# UNITED STATES PATENT AND TRADEMARK OFFICE

APPLICATION NO.	FILING DATE	FIRST NAMED INVENTOR	ATTORNEY DOCKET NO.	CONFIRMATION NO.
10/743,458	12/23/2003	Tsuyoshi Kubota	90606.2/wa	8146

## Office Action Summary

## **DETAILED ACTION**

**Figure 19**

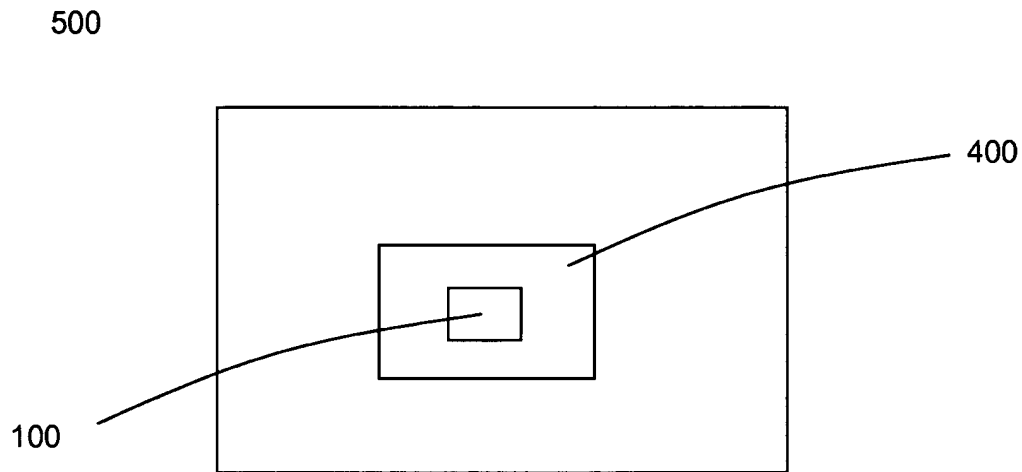
OK to enter, Ch
